TORLINE ADDITION

Re: S/D 94-84 - TORLINE ADDITION (Final Plat)

Re: S/D 94-84 TORLINE ADDITION (Final Plat)

CASE NUMBER: S/D 94-84 TORLINE ADDITION

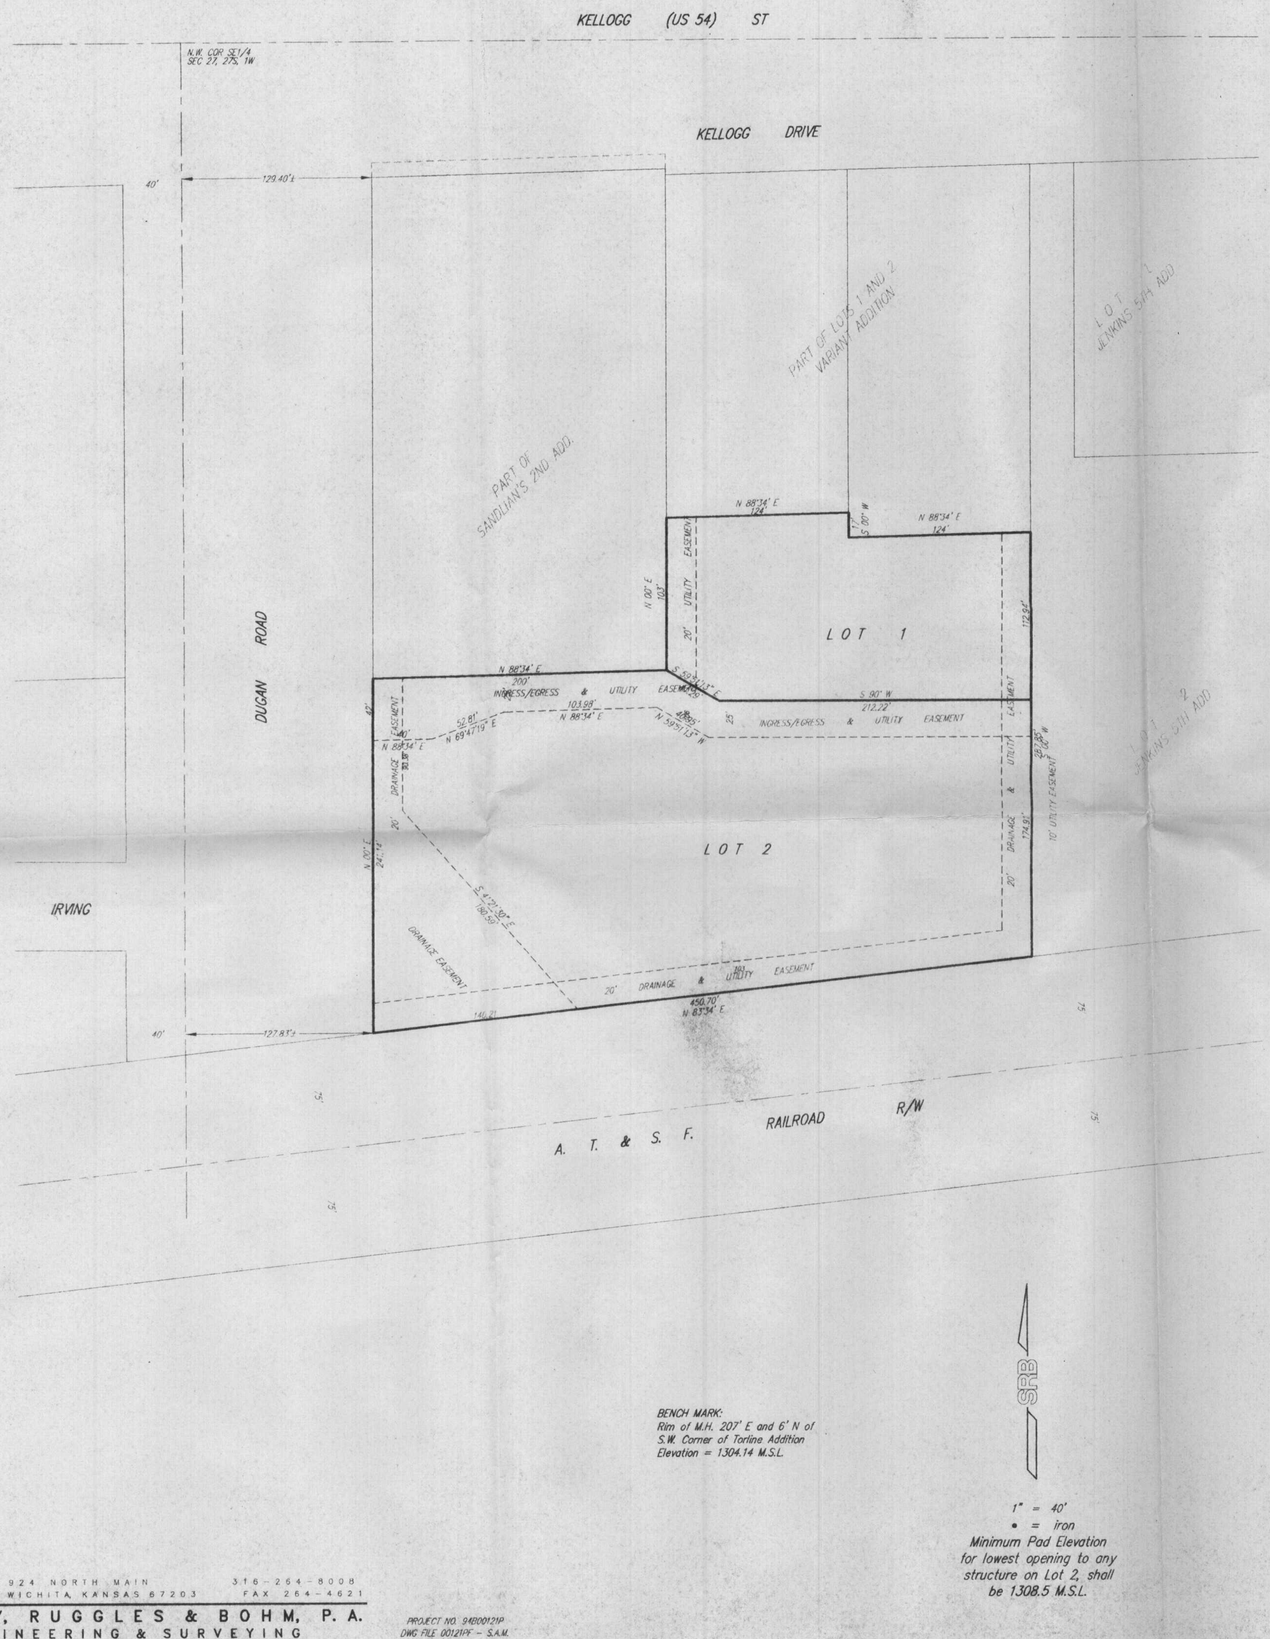
A. The applicant shall guarantee both the abandonment and reconstruction of sanitary sewer to serve this site. As requested by City Engineering, temporary easements shall be submitted for any existing facilities intended for relocation and not being covered by a platted easement in this addition.

B. As necessary, the applicant shall guarantee the extension of municipal water to serve the lots being platted. In particular, an extension to Lot 1 may be needed if a private easement cannot be obtained to cover the existing service line to the building now located on this lot.

C. The applicant shall guarantee any drainage improvements required by the platting of this property. As requested by City Engineering, a temporary drainage easement shall be submitted which covers the existing drainageway until such time as the intended improvements are complete.

E. Since it is likely that the only access to this site from Dugan will be in the area of the Ingress/Egress easement, complete access control shall be indicated to Dugan along Lot 2's frontage south of this easement. Both the face of the plat and plattor's text shall note such access control.

an access easement rather than direct access to a public street, such easement is a privately established and maintained situation. However, the applicant is required to create and record such an easement. This easement then needs to be shown on the plat tracing with the recording information. The easement also needs to first be submitted to Planning for review. This easement needs to specify who will benefit from the easement, who will install and maintain within the easement the required driving surface, that the easement cannot be impeded in any way, and the easement is binding on future owners or assigns.

At a minimum, the plattor's text shall also note the creation of such a private ingress/egress easement, noting also which property it benefits and that it is not to be blocked in any way.

G. On the final plat, a 35 foot building setback shall be platted along this site's frontage to Dugan, that is in the area not now encumbered by easements at least 35-feet in depth from Dugan.

H. If this plat is dedicating any right-of-way for Dugan, it shall be indicated on the face of the plat and the plattor's text shall also note that the street is being dedicated to and for the use of the public. If no such right-of-way is actually being dedicated by this plat, the reference in the plattor's text to such a street needs to be deleted.

L. On the final plat tracing, the MAPC signature block shall be amended to indicate John W. McKay, Jr., as Chairman.

R. The final plat shall indicate the utility easements requested by K.G.& E. and Southwestern Bell which are indicated on the enclosed "marked" copy of the plat.
Long. = 20', but only want 10' now 12/29/94
Also, prior to this plat being scheduled for City Council review, the applicant shall submit letters from KG&E and Southwestern Bell indicting that satisfactory arrangements have been made for the relocation of their facilities made necessary by this plat.

S. As indicated by City Engineering, the drainage area at the west and southwest portion of this plat should be shown as involving a floodway and the plattor's text amended to reference the standard floodway language.
